CASE SUMMARY SHEET

CASE NUMBER: V26-03-05**DATE RECEIVED: January 22, 2026****DATE OF MEETING: March 10, 2026 and March 24, 2026****Address: 2801 Lakeshore****Subdivision: West Beach Parkway, Square 1 Lot 1-A****Zoning District: R-1 - Single Family Residential District****Property Owner: William and Caroline Alquist**

REQUEST: V26-03-05 – William and Caroline Alquist request a variance to CLURO Section 5.2.3.2. Drainage Overlay District and Fill Sub-Area A, Section 9.2.5.2. Vegetation Protection Zones, and Section 8.1.5. Supplemental Regulation of Accessory Buildings and Structures, West Beach Parkway, Square 1 Lot 1-A, R-1 - Single Family Residential District, 2801 Lakeshore

CASE SUMMARY: Construct a raised pool within the street side setback and a live oak vegetation protection zone

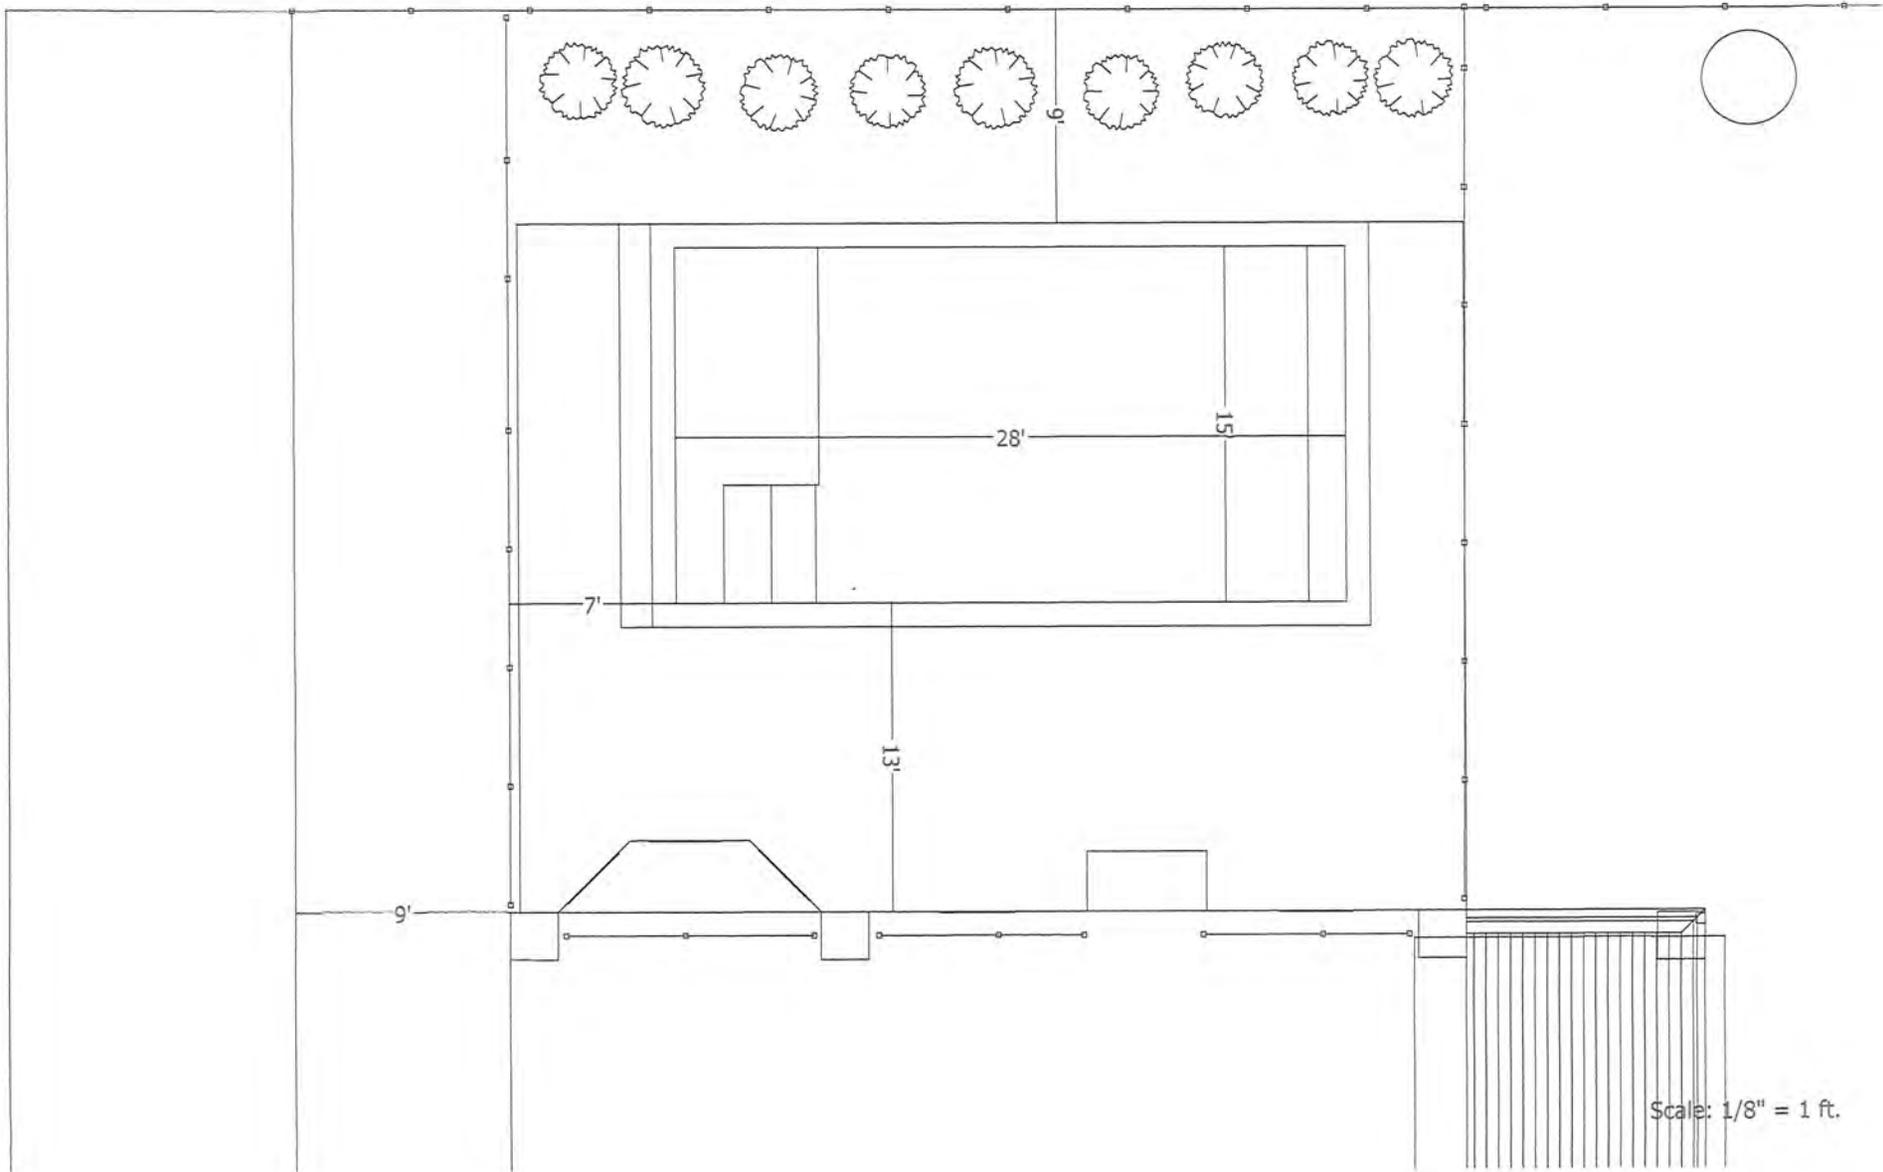
The applicant is requesting to construct the pool 2' above grade, with an additional 2'-6" on top of the pool coping on the street side for a waterfall feature. Public Works reviewed the request and had the following comments: *"The proposed height will need to be indicated if the variance is approved so Public Works can verify the as-built condition. According to the Elevation Certificate the bottom slab is at a height of 3.20 ft. The front coping should not exceed 5.2 and the "water wall" should not exceed 7.70 NAVD 88. These specifics should be part of the request. A drainage plan will need to be submitted at the time of permit to ensure proper storm water runoff."*

The proposed height will need to be indicated if the variance is approved so Public Works can verify the as-built condition. According to the Elevation Certificate the bottom slab is at a height of 3.20 ft. The front coping should not exceed 5.2 and the “water wall” should not exceed 7.70 NAVD 88. These specifics should be part of the request. A drainage plan will need to be submitted at the time of permit to ensure proper storm water runoff.

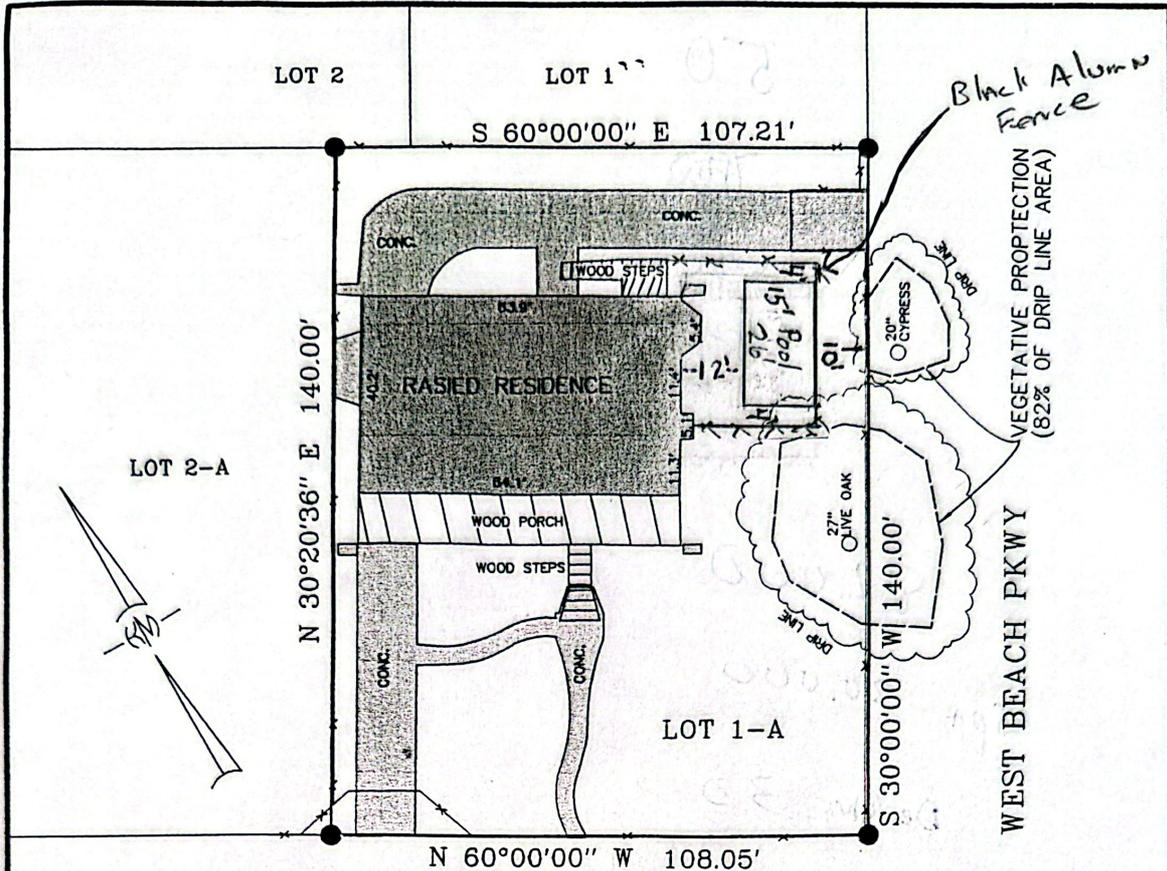
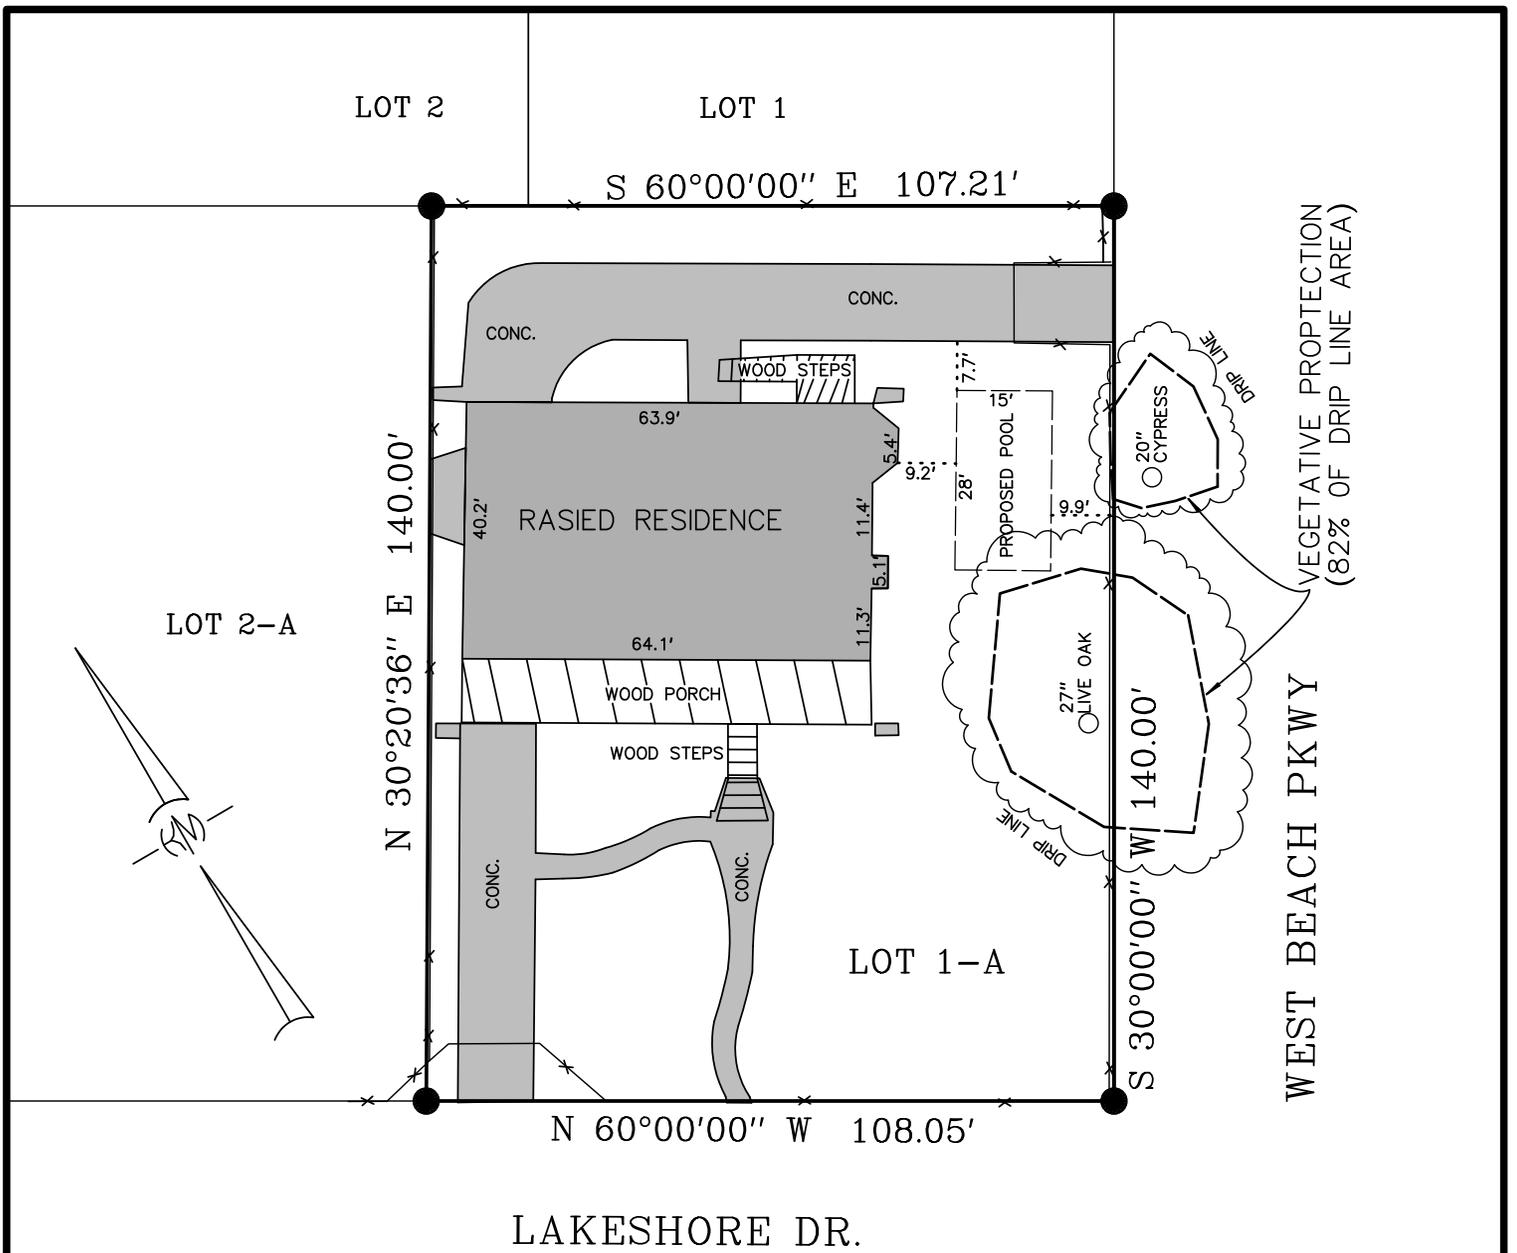
The pool is located in the street side yard 10' from the property line. Regulations require that accessory structures cannot be located within the street side yard. In the R-1 District the street side yard setback is required to be 15'. The pool would encroach 5' into the required setback area.

There is a 27" live oak located on the east side of the property. The pool itself will be located outside of the vegetation protection zone, however a portion of the required fence barrier and some of the decking will be located within the vegetation protection zone. The applicant stated that there will be 6' of decking within the protection zone and the fence will be a 4' black aluminum fence.

At the last meeting the Commission requested a revised site plan to see if the pool layout could be adjusted to move it out of the live oak vegetation protection zone. The applicant submitted a revised layout that reduced the pool by 2' in length to bring the fence and decking area outside of the vegetation protection zone. This layout would eliminate the vegetation protection zone variance, leaving only the variances for fill and pool location.

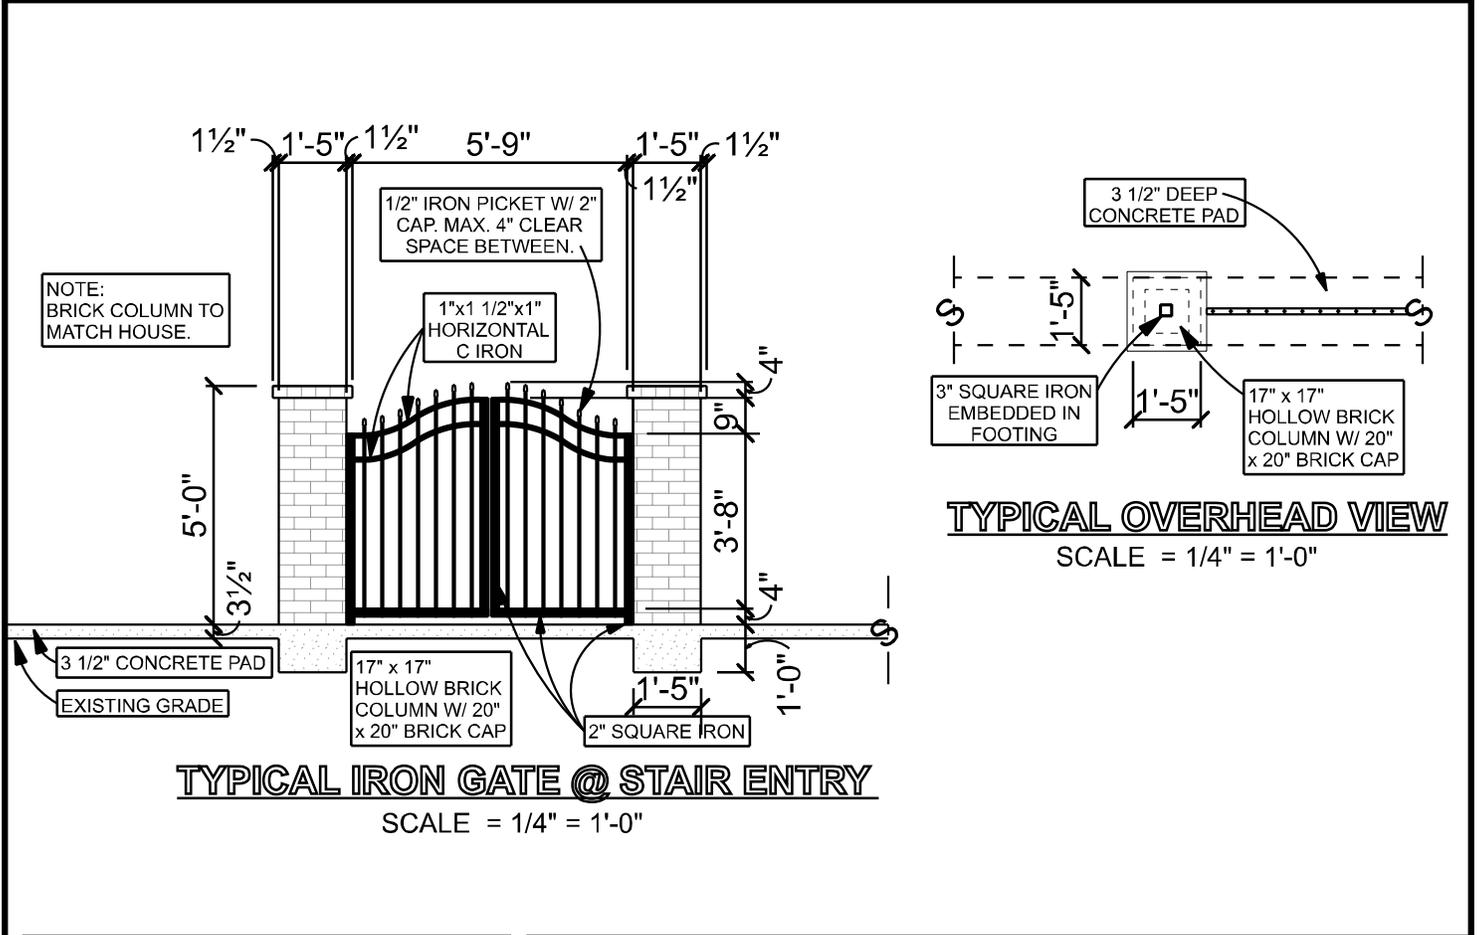
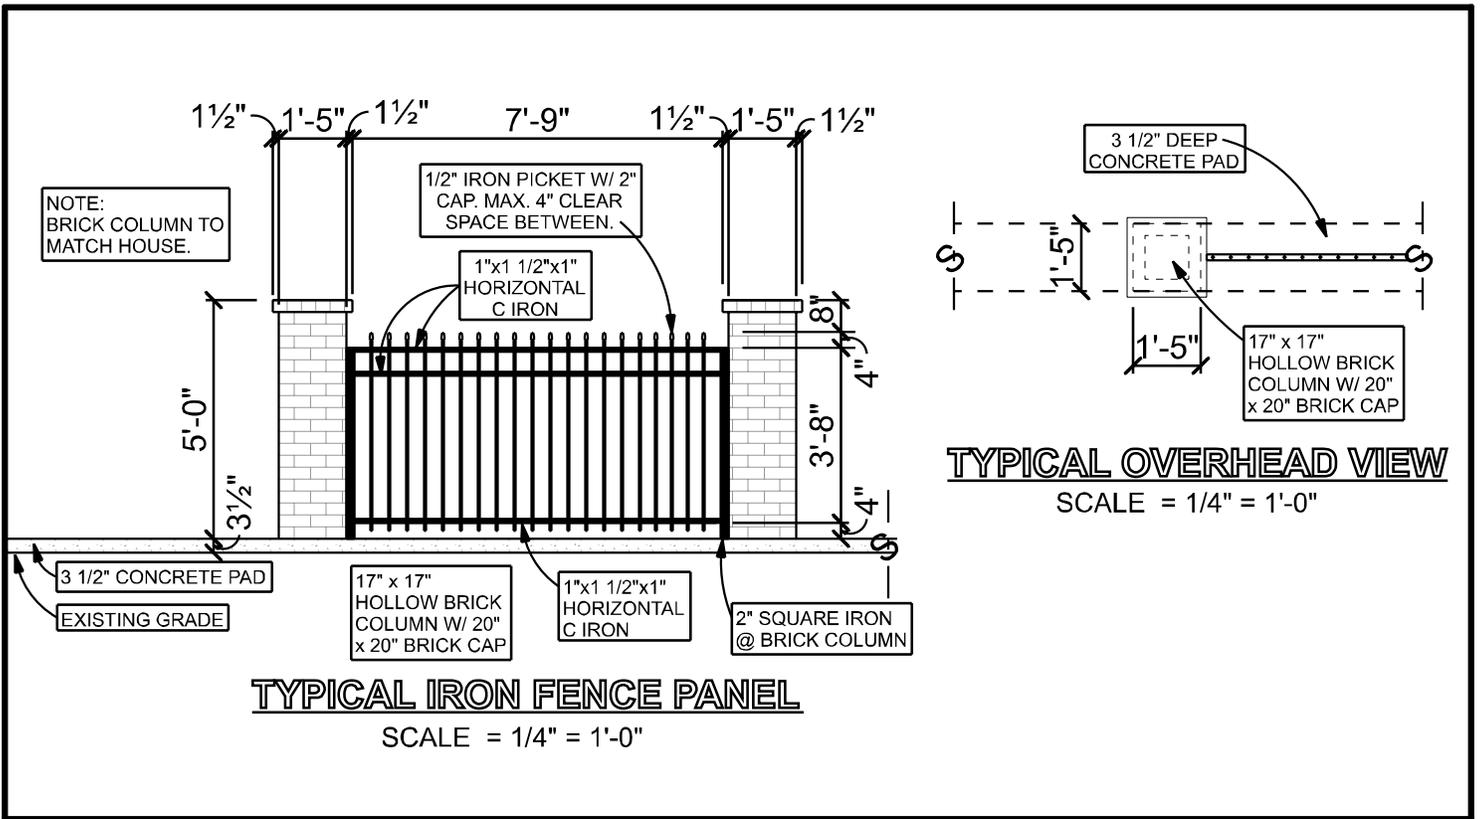
Prior to the start of construction there was a wrought iron fence installed along the front property line and located within the vegetation protection zone of the live oak at the front of the property. The homeowners want to replace the fence with a new iron fence and brick columns. Per the submitted fence specifications there will be a 3 ½" concrete pad running underneath the length of the fence, with 12" footings located at the gate piers. The concrete pad has already been constructed without approval.

The City Arborist performed a site inspection and had the following comments: *"The owners of 149 Coffee installed a fence without first obtaining a permit. That permit could have been approved if it was submitted prior to the installation and showed that the soil disturbance was no greater than 3 inches deep within the dripline of the tree. This is a unique style of fence construction that appears to use footing rather than posts. After an onsite inspection, my assessment is that the tree roots were harmed. I measured about 12 inches of disturbance (depth) near the base of the tree and at least 5 inches in several other places. The CULRO - specifically article 9.1.2 - does not give me the power to approve of something with this much disturbance. Therefore, a variance is required for something of this depth within the dripline of the tree."*

At the last meeting the Commission requested a report from Bayou Tree Service. The report states that *"After looking at the new concrete for the new fencing to put in I don't see any real negative impact that would have done to the live oak in front. The concrete pour seems to be at grade level or one to two inches below grade where no major roots were affected."*
